STAFF REPORT: AUGUST 9, 2023 REGULAR MEETING

APPLICATION NUMBER: 23-8483

ADDRESS: 2432 W BOSTON

SCOPE: REHABILITATE DWELLING AND GARAGE

Pella Lifestyle Contemporary sliding door. Rendering from product website.

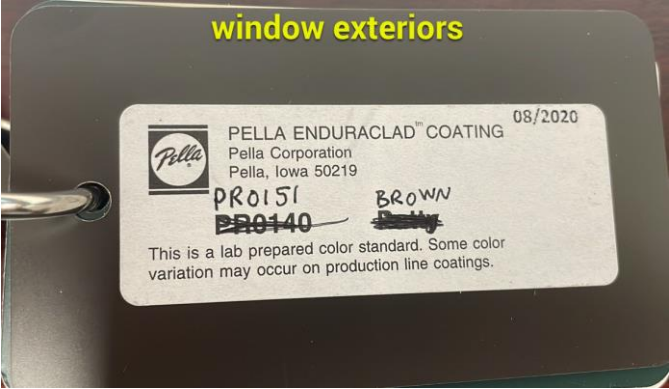
- Windows 17 and 18, located within a larger bay window on the south (rear) elevation, are proposed to be replaced with a larger, sliding door. This would necessarily require enlarging the opening. Staff suggests that while the bay window itself is a character-defining feature, the placement of individual units within the bay window is not. Also, as noted above, the windows are already missing. Thus, staff suggests that the guidance of *Evaluating Historic Windows for Repair or Replacement* (National Park Service, 2007) applies: “The number of windows being replaced is a consideration that may allow for window replacement that does not depend on deterioration. It may be possible that the replacement of a few windows may have only an inconsequential effect on the character of an elevation with many windows. Thus, where a need such as egress can be achieved with little change to the appearance of the building, a few windows may be replaced irrespective of their condition.

Proposed replacement materials. Images from application documents.

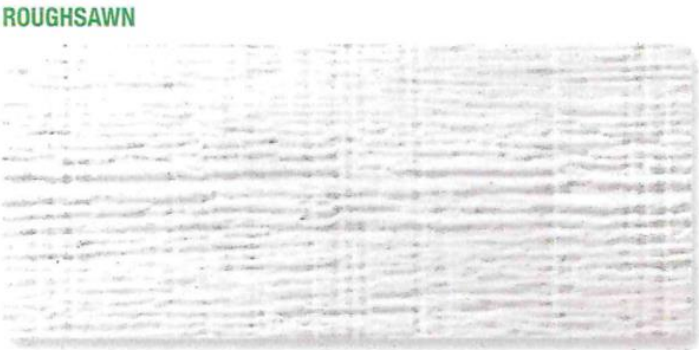
- The application includes a photo showing that one area of the soffit has deteriorated; however, there is not enough information to determine if the entirety of the soffits on the house and garage have deteriorated beyond repair. Standard #6 directs that the replacement of historic features shall be avoided unless they are deteriorated beyond repair.

- Further, Standard #6 states that a synthetic replacement would not be appropriate: “Where the severity of deterioration requires replacement of a distinctive feature, the new feature shall match the old in design, color, texture, other visual qualities, and where possible, materials.” Thus, a replacement should be wood, rather than the proposed James Hardie soffit and trim.

- Existing historic window trim will be retained. If it is deteriorated beyond repair, its replacement will be subject to approval by staff.
- The soffit panels may be replaced only to the extent that they have deteriorated beyond repair. The new soffit and trim panels will be wood rather than synthetic fiber-cement panels and will be painted a color selected from Color System D or another color approved by staff.
- The color of the proposed rear (south) doors will be a color selected from Color System D or another color approved by staff.
- The selection of garage doors will be subject to approval by staff.
- The color of gutters will be a color selected from Color System D or another color approved by staff.

Left: Existing porch doors, photos from application. Right: Pella Reserve Traditional door (shown without simulated divided lights), image from product website.

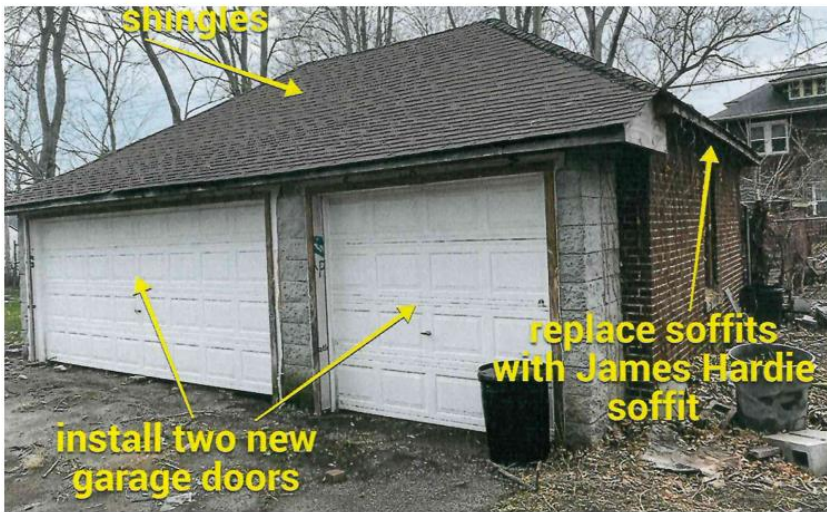
- The proposed rear (south) door and storm door replaces a non-historic door with a compatible new door.
- The existing porch doors do not appear to be intended for exterior use and may date from the era when the porch was enclosed. Due to their recessed, west-facing location, they are minimally visible. Staff suggests that their replacement is appropriate.

- Specifications for the proposed west-facing porch doors are not provided in the application materials.
- A cut sheet provided for the proposed garage doors provides several options for colors, textures, and glazing, but does not indicate which options are proposed.
